# Bic

380cc

## PrintArea

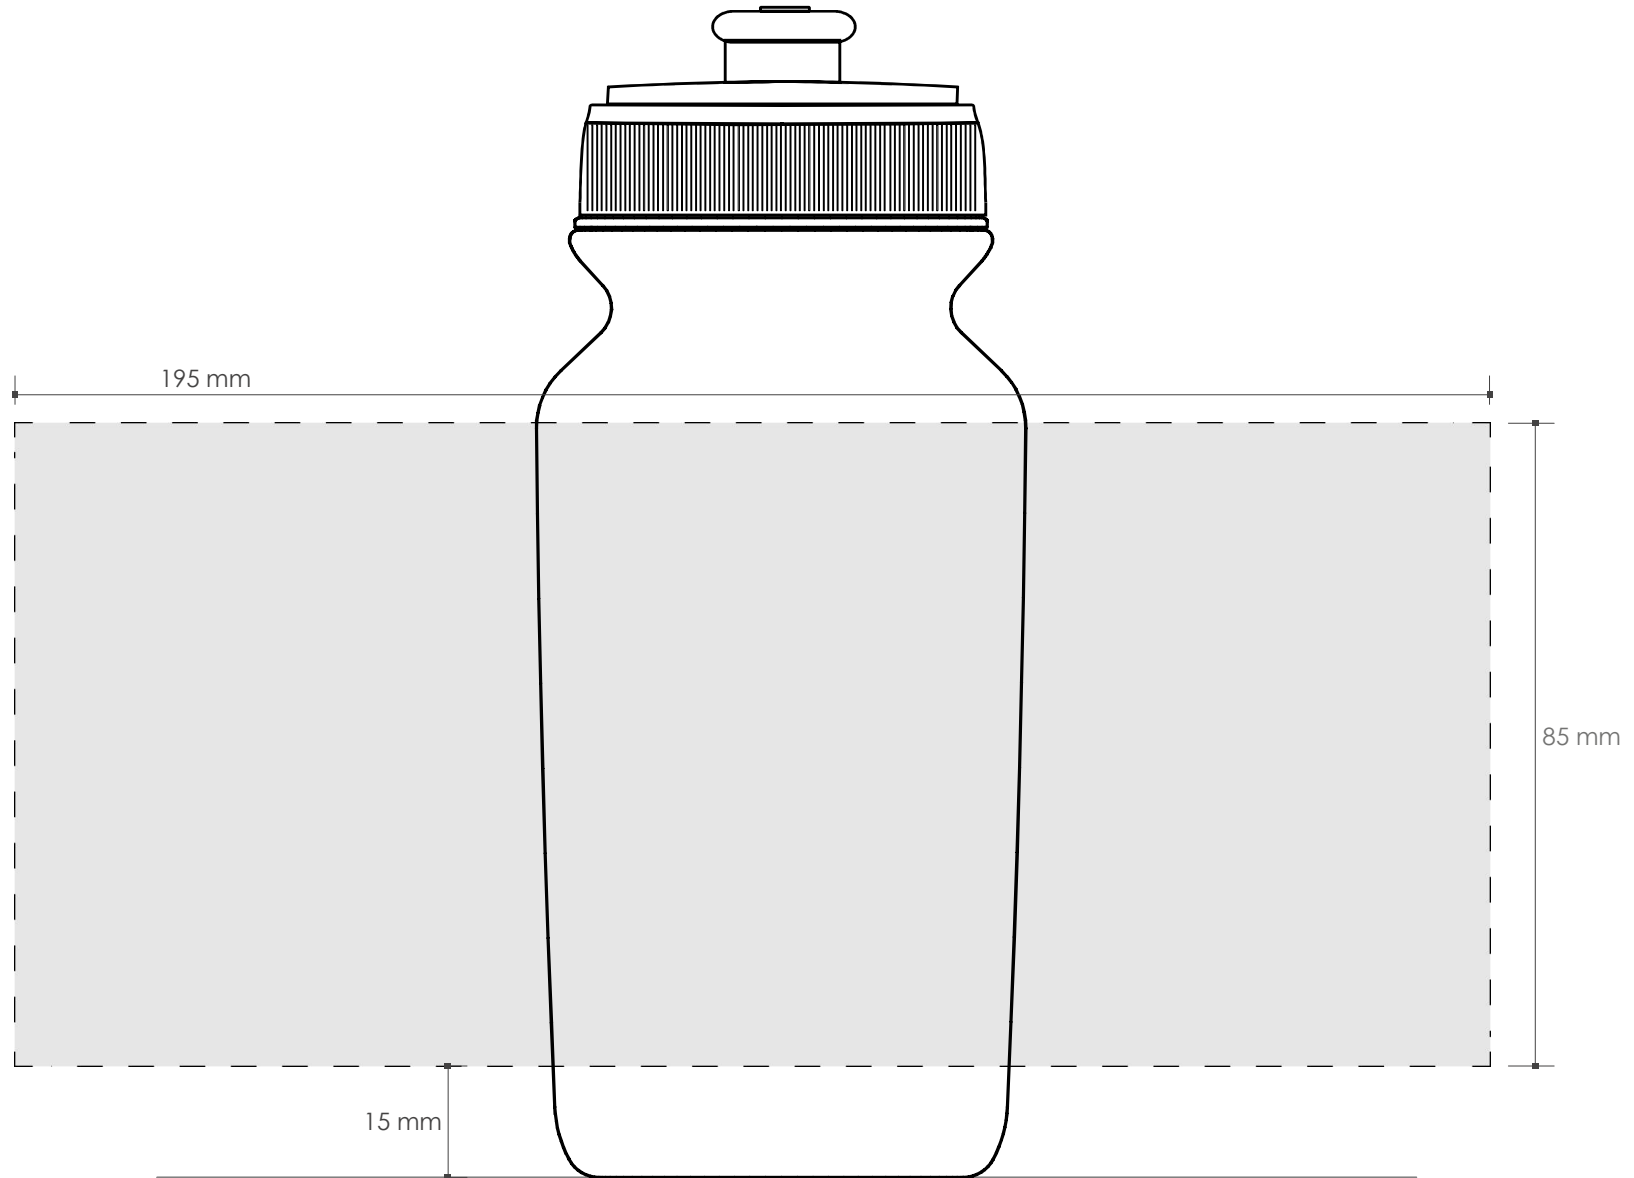
The impression can not close on the circumference of the bottle:  
it's necessary to consider a non-printable area (approx. 0,8 cm width)
